November 24, 2010

Subject: Response to Department of Toxic Substances Control's Comments on the "Letter Work Plan to Evaluate Groundwater in Select Areas at the University of California Richmond Field Station, Richmond, California."

Subject: Revised Letter Work Plan to Evaluate Groundwater in Select Areas at the University of California Richmond Field Station, Richmond, California

FIGURE 2

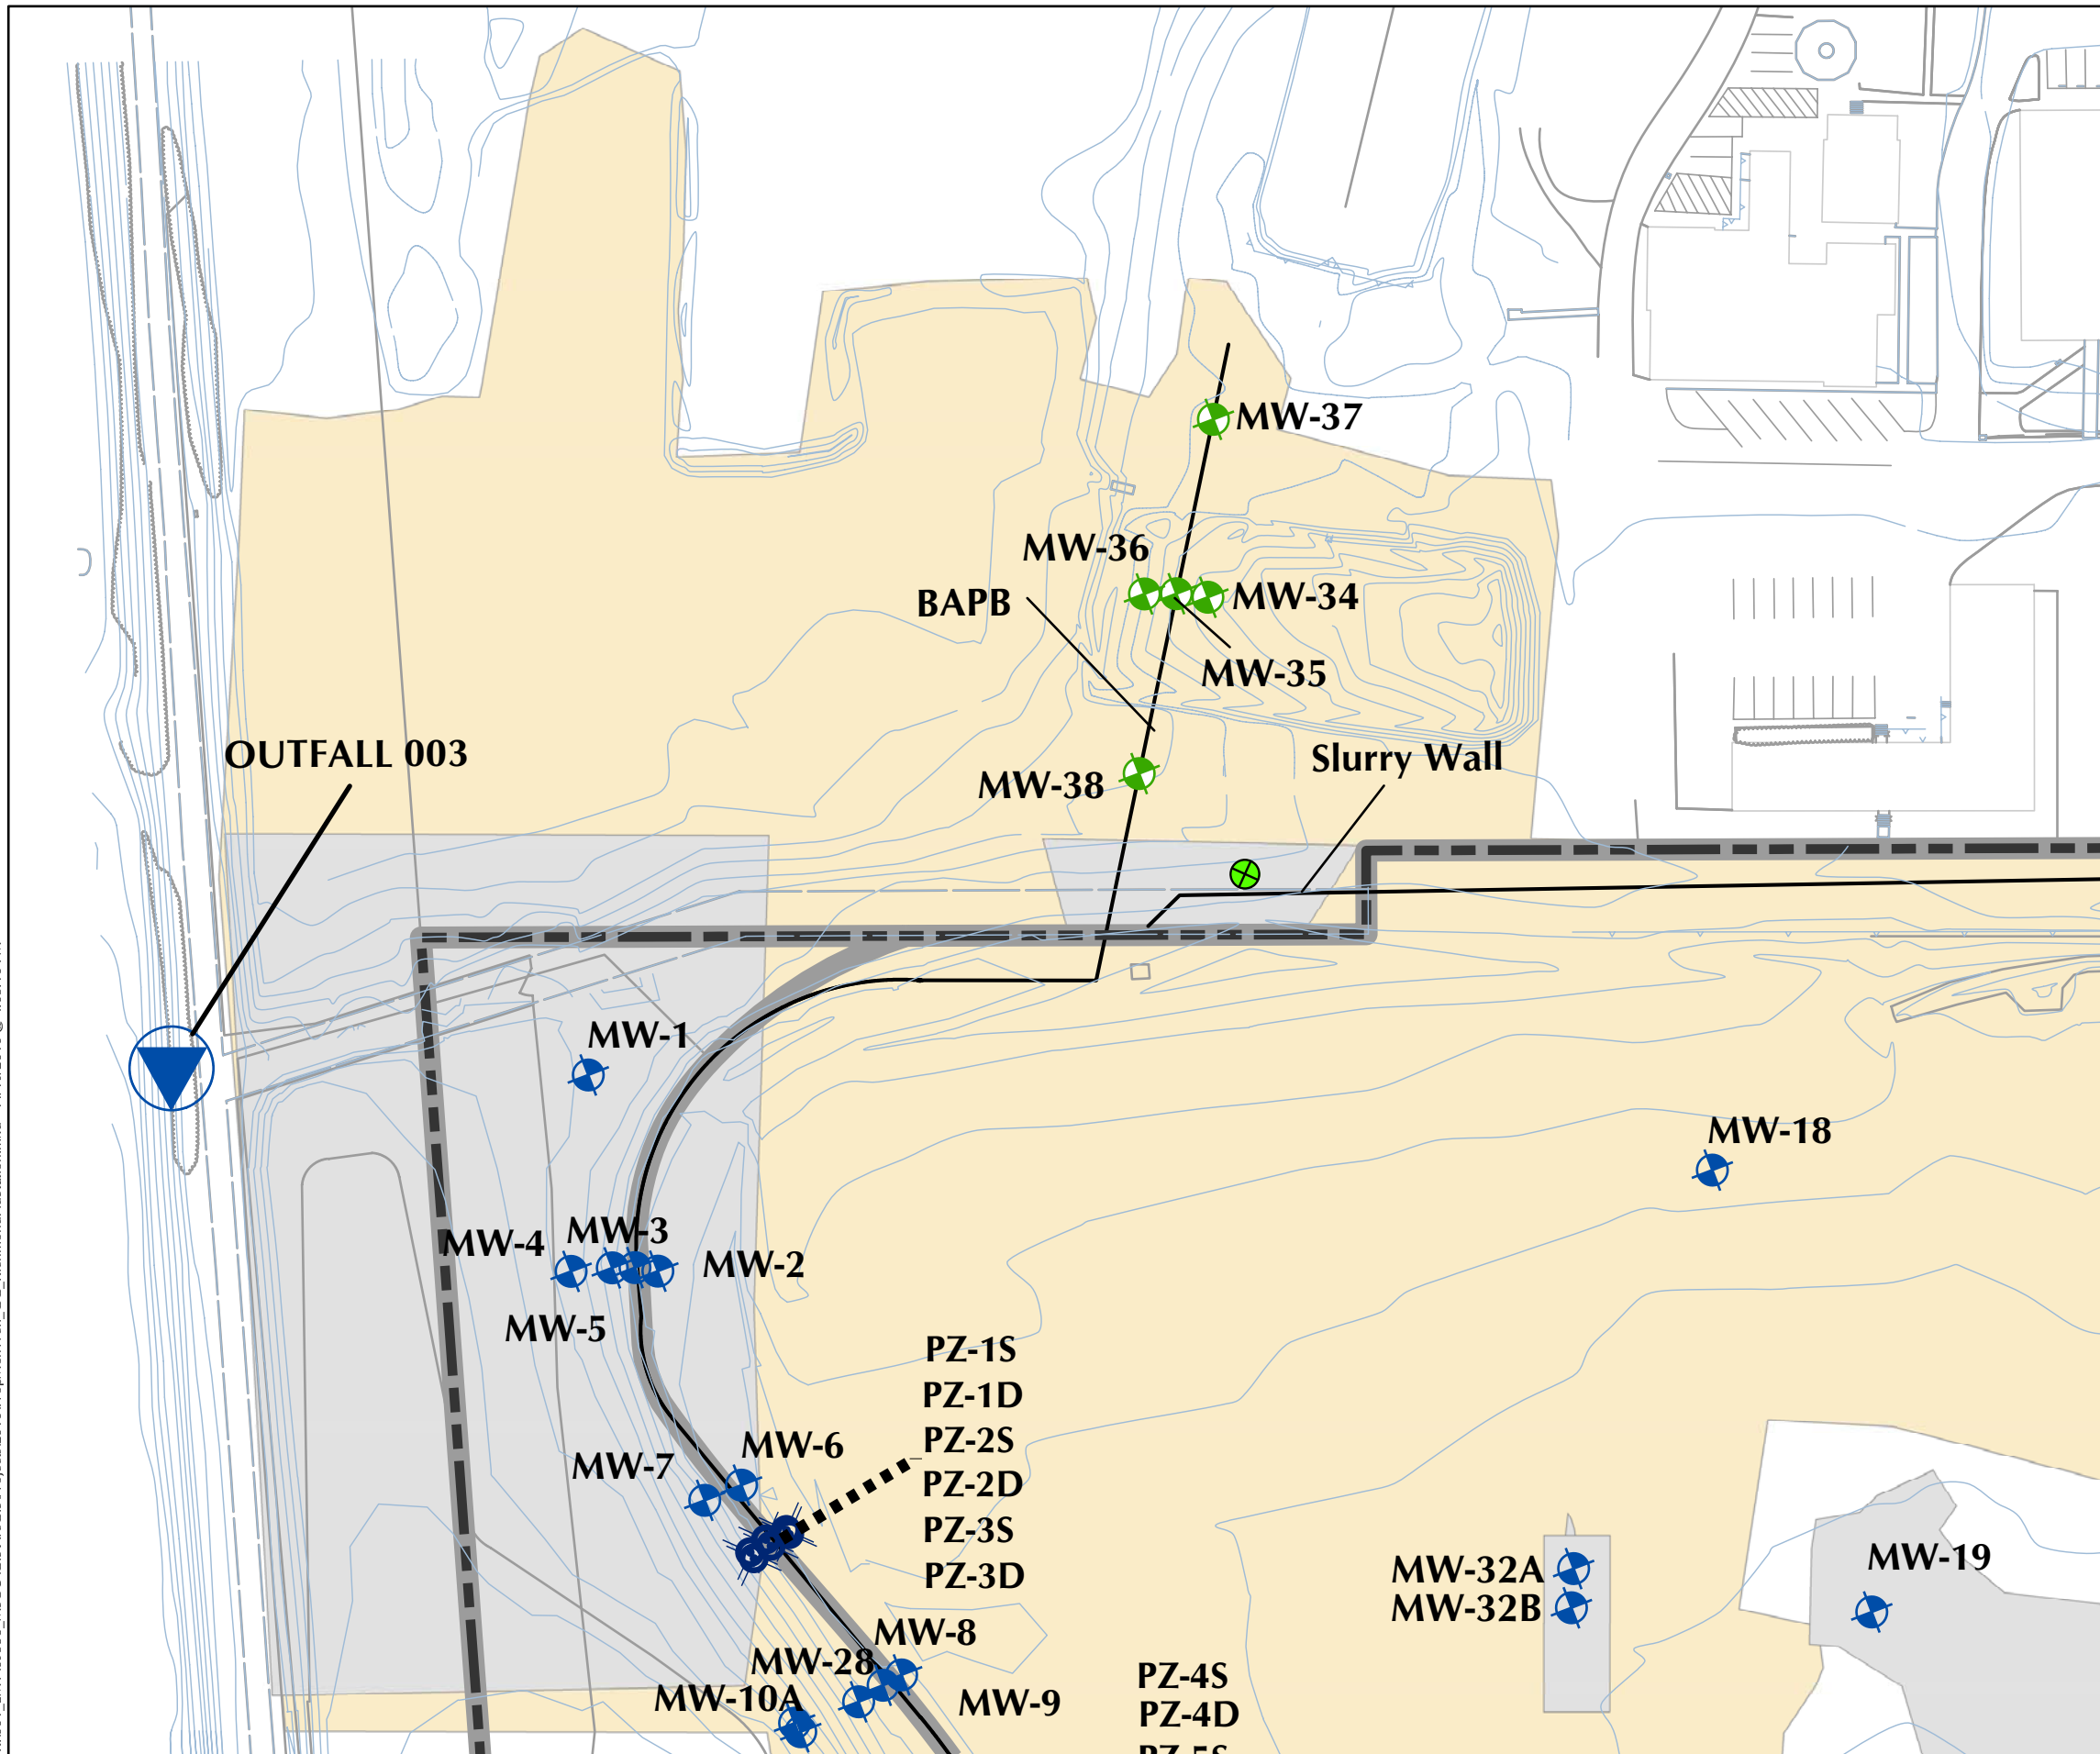
The location of the grab sample near the slurry wall should be moved about 180 feet south along the wall.

To address this comment, Figure 2 has been revised so that the location of the grab groundwater sample near the slurry wall has been moved approximately 180 feet south along the wall and the Work Plan will be implemented accordingly.
